## Meeting Minutes

PROJECT: COA – North Domingo Baca Aquatic Center LOCATION: Virtual Meeting (GoTo Meeting)

PROJECT NO.: P312254.01

PURPOSE: Design Meeting 03

Existing Site

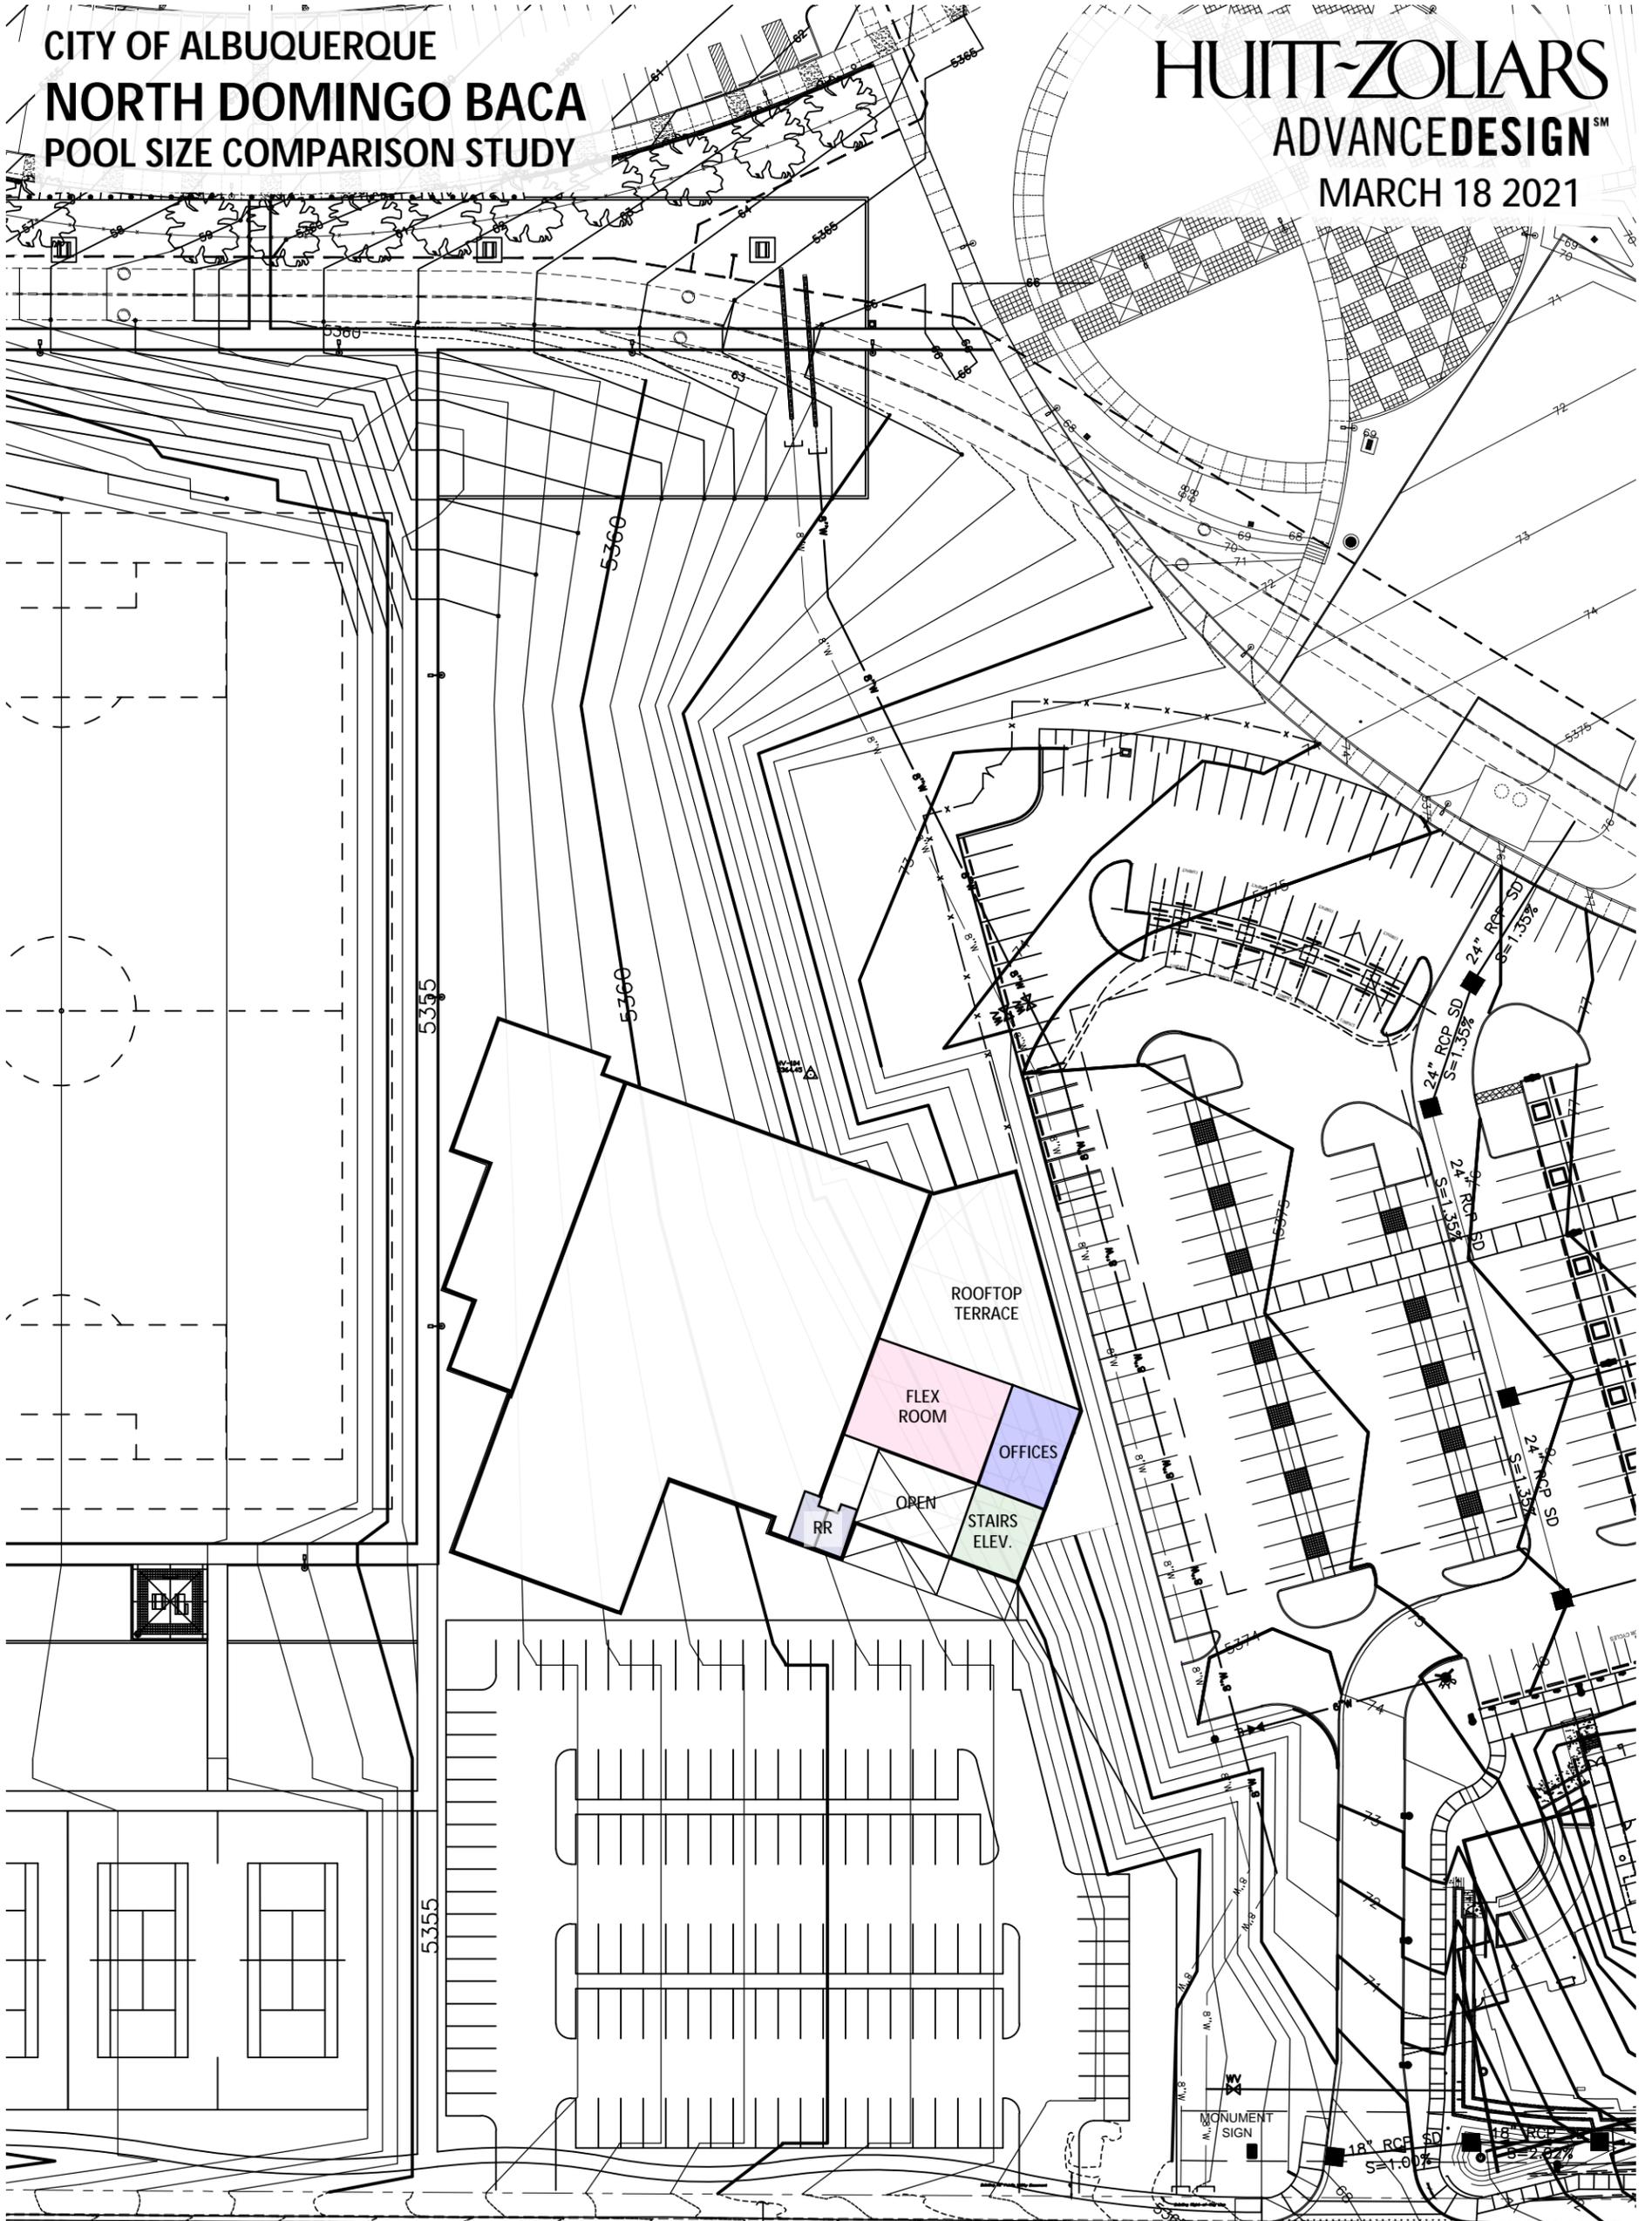
1. JZ presented the orientation of the parking lot, building location, and the outdoor pool locations (see attachments).
  - a. Discussed the site grading issues; the site gets narrower and steeper as it moves from the south to the north.

- b. The primary views are to the NE. Opening up to the north light is preferable to avoid any potential glare issues into the facility.
  - c. Any glazed openings on the west side will need to be designed to protect from glare entering the facility.

- d. A connection to the upper parking lot will be provided.
  - e. Access to the parking lot will be from the Carmel only. The grade change from the existing access west of the gym eliminates the potential use of this access road to the new facility.

- f. An access point to the pool mechanical room is required from a service road, parking lot or street.
2. COA is actively looking to purchase parcel(s) of the vacant land south of NDB. Should this occur, the building could be moved further south to fill the area that is currently identified as parking. Additional parking could move north of the facility.

25 YARD POOL  
SECOND FLOOR  
1/64" = 1'-0"

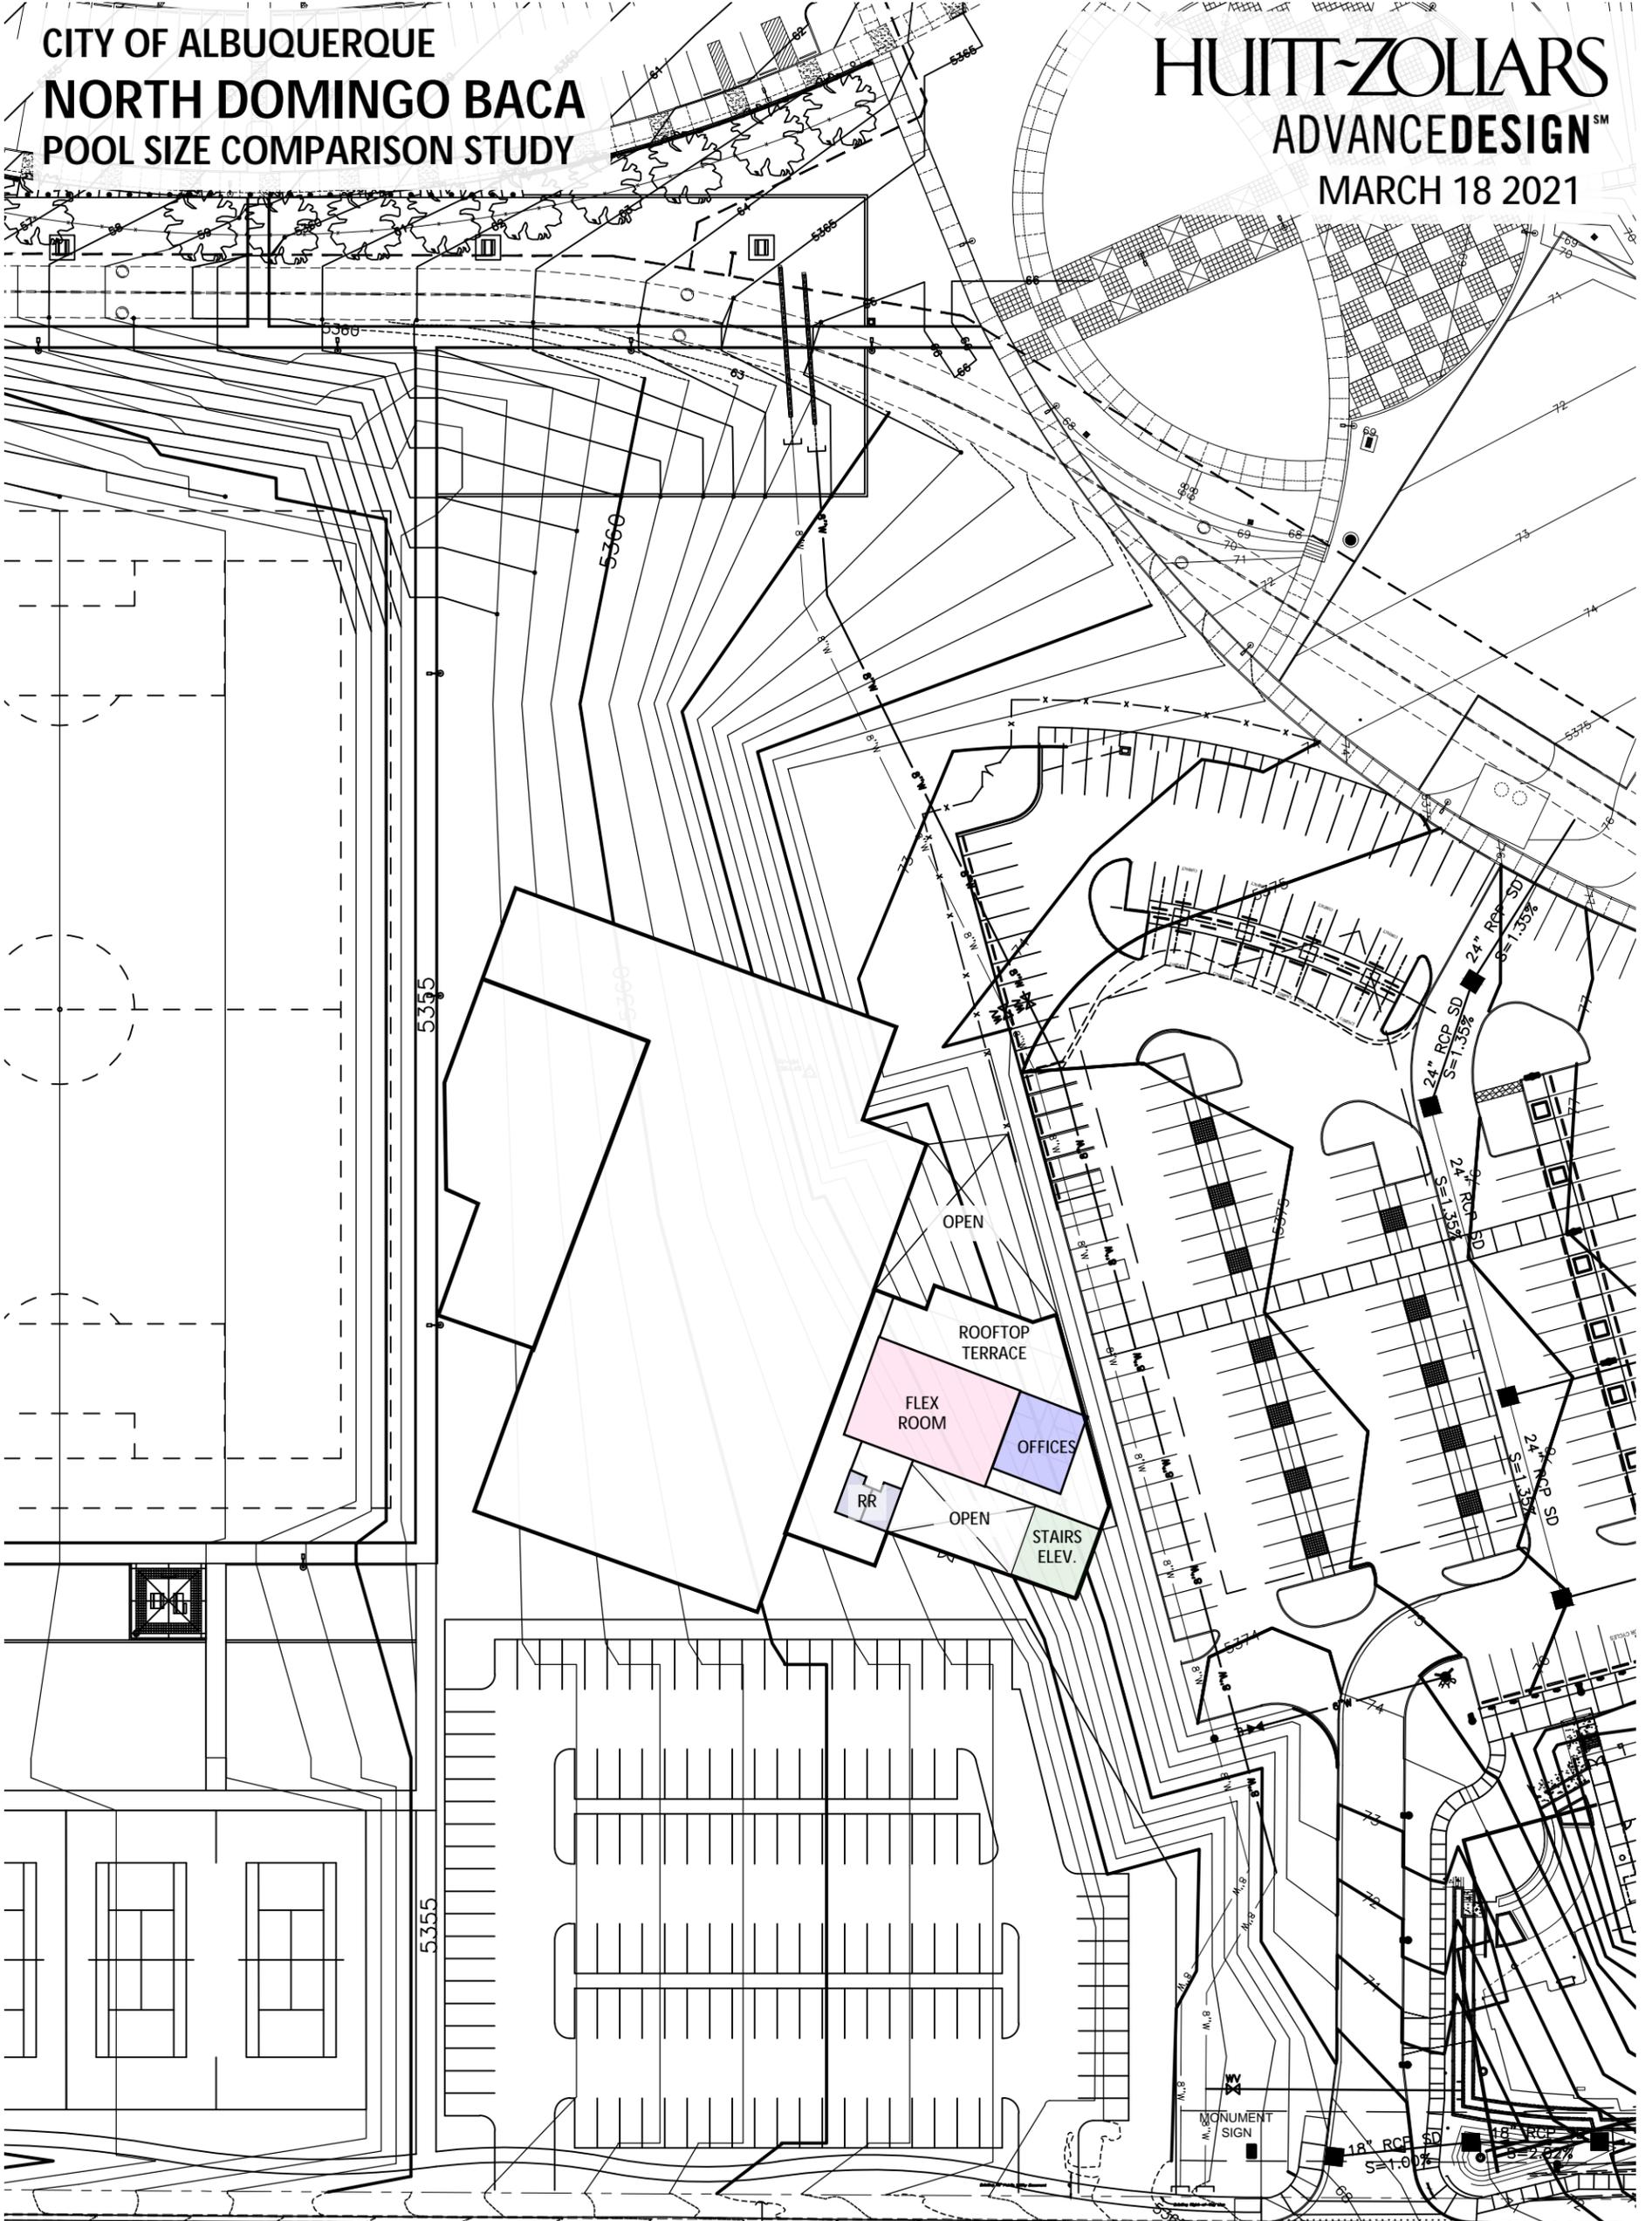
3. HZ presented 2 scenarios (see attachment). JZ discussed that the purpose of this exercise is to look at the programmatic element sizes and relations. This is not meant to be a design, but a tool to discuss the sizes and how it impacts the site. The design effort will follow once a decision is made on the pool size (25x25m or 50m).

- d. The outdoor pool will incorporate landscape areas to integrate with the surrounding site.
  - e. Reviewed 2nd level spaces: access to parking, circulation connecting indoor pools. Potentially there could be an exterior access route to the outdoor pool without entering the building.

- f. Spectator seating will be moved to a mezzanine level to allow access to the pool from below the spectator seating, and reduce the size of the natatorium space. It is the preference of the owner to have spectator seating on the second level.

- i. SM mentioned that the spectator seating is required to be separated from competition pool area.
    - ii. JH mentioned that the control room could be below the seating area (below the bleacher area).

- g. SM mentioned moving the restrooms more north to help centralize facilities (for 50m option). The outdoor folks would need to travel through the entire facility currently (sim to West Mesa); would like the outdoor pool closer to the hygiene area.
